ELSA 4th meeting, November 14, 2008

ELECTRICAL SAFETY PROVISIONS FOR VEHICLES Post Crash**1. General**

Figure 12: Measurement of V_b , V_1 , V_2

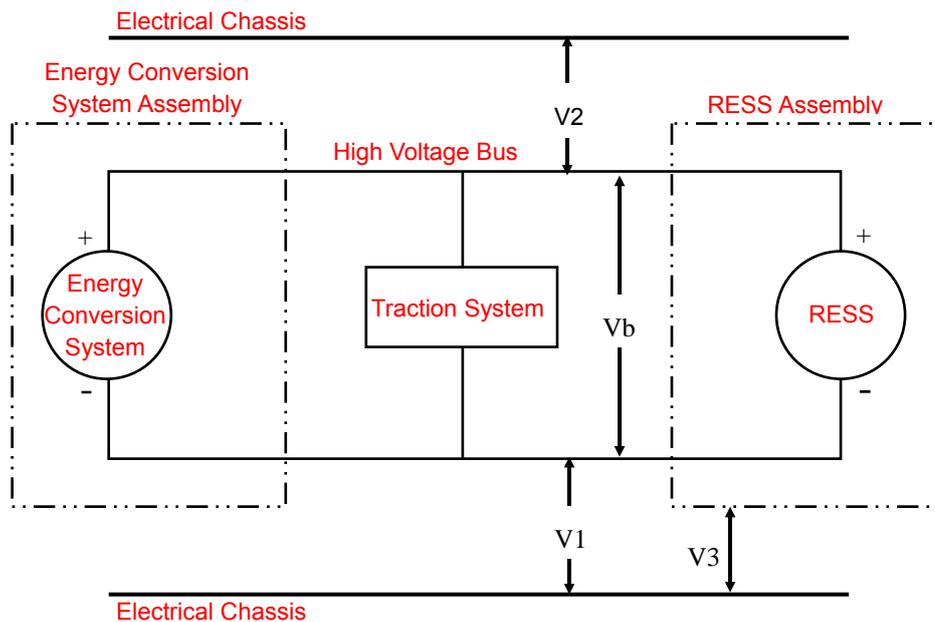
[Prior to the vehicle crash test measure and record the high voltage bus voltage (V_b) (see Figure 12). If V_b is high voltage, conduct the specified vehicle crash test]. After the crash test, determine the high voltage bus voltages (V_b , V_1 , V_2) (see Figure 12). [If the Energy Storage Device Assembly RESS is designed to be isolated with respect to vehicle chassis has exposed conductive parts portions, measure the voltage V_3 between any exposed conductive parts portions of it and the electrical chassis.]

Measure and record the voltage (V_b) between the negative and the positive side of the high voltage bus (see Figure 1):

Measure and record the voltage (V_1) between the negative side of the high voltage bus and the vehicle electrical chassis (see Figure 12):

Measure and record the voltage (V_2) between the positive side of the high voltage bus and the electrical chassis (see Figure 12):

Figure 23: Measurement of V_1'

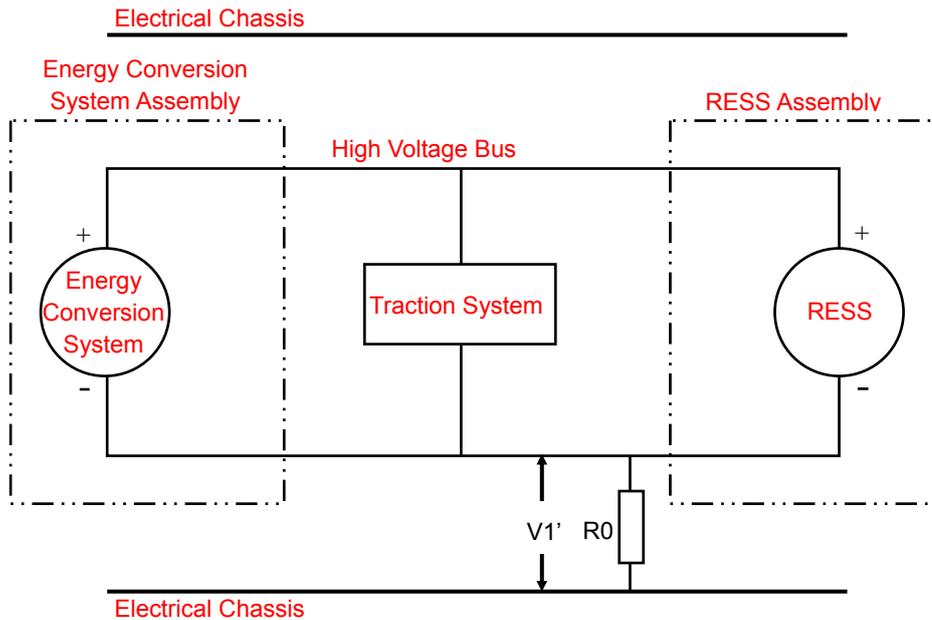
If V_1 is greater than or equal to V_2 , insert a standard known resistance (R_o) between the negative side of the high voltage bus and the **vehicle electrical** chassis. With R_o installed, measure the voltage (V_1') between the negative side of the high voltage bus and the vehicle electrical chassis (see Figure 23). Calculate the **electrical-isolation resistance** (R_i) according to the formula shown. Divide this electrical isolation resistance value (in ohms) by the **nominal operating working** voltage of the high voltage bus (in volts).

Figure 34: Measurement of $V2'$

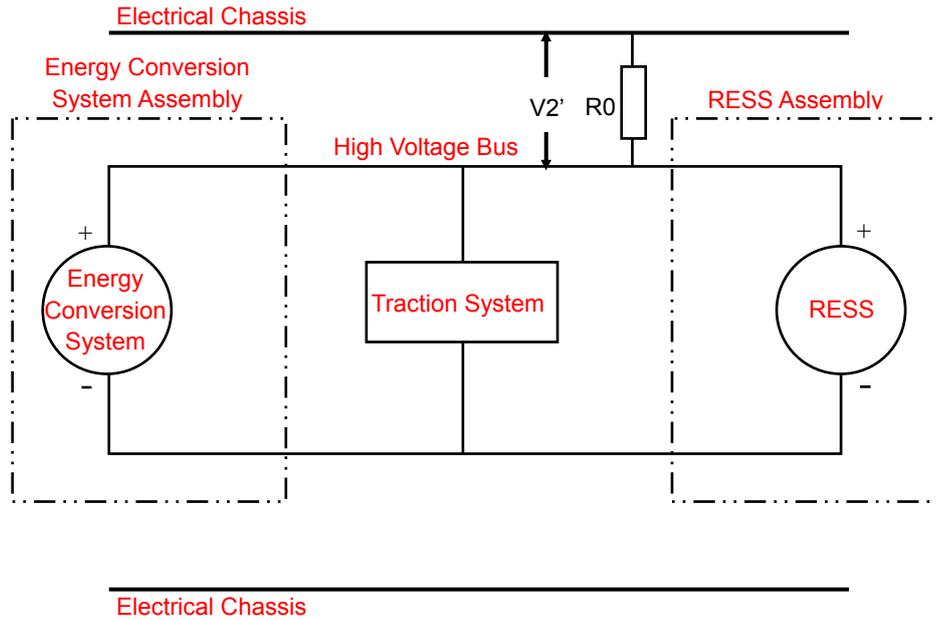
If V_2 is greater than V_1 , insert a standard known resistance (R_o) between the positive side of the high voltage bus and the **vehicle electrical** chassis. With R_o installed, measure the voltage (V_2') between the positive side of the high voltage bus and the **electrical vehicle** chassis (See Figure 34).

Calculate the **electrical-isolation resistance** (R_i) according to the formula shown. Divide this electrical isolation value (in ohms) by the **nominal operating working voltage** of the high voltage bus (in volts).

Figure 45: Measurement of high voltage bus energy

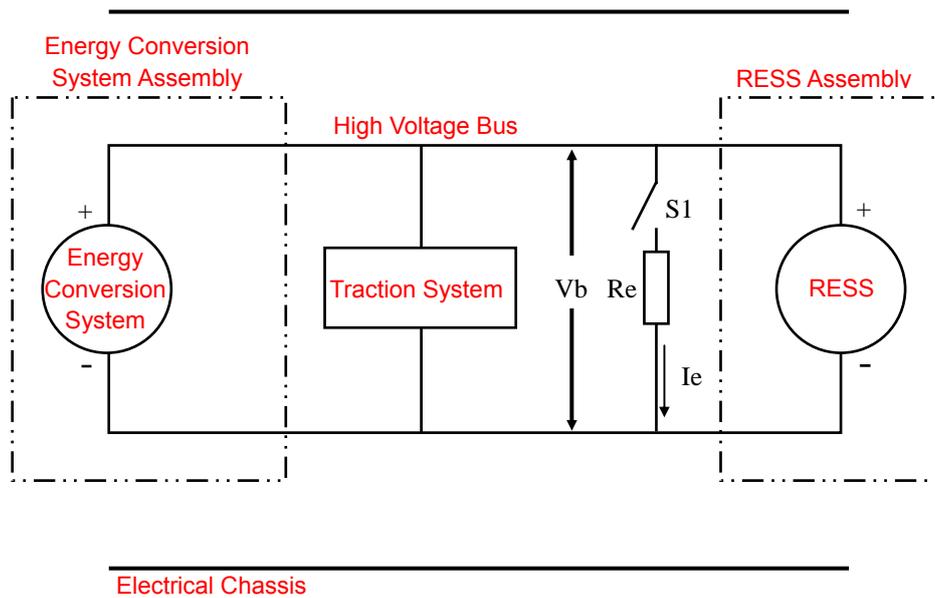
After the vehicle crash determine the high voltage bus energy (see Figure 45). Install switch S1 and known resistance R_e . Close switch S1 and measure and record voltage V_b and current I_e .

$t_0 = ???$
 $t_1 = ???$
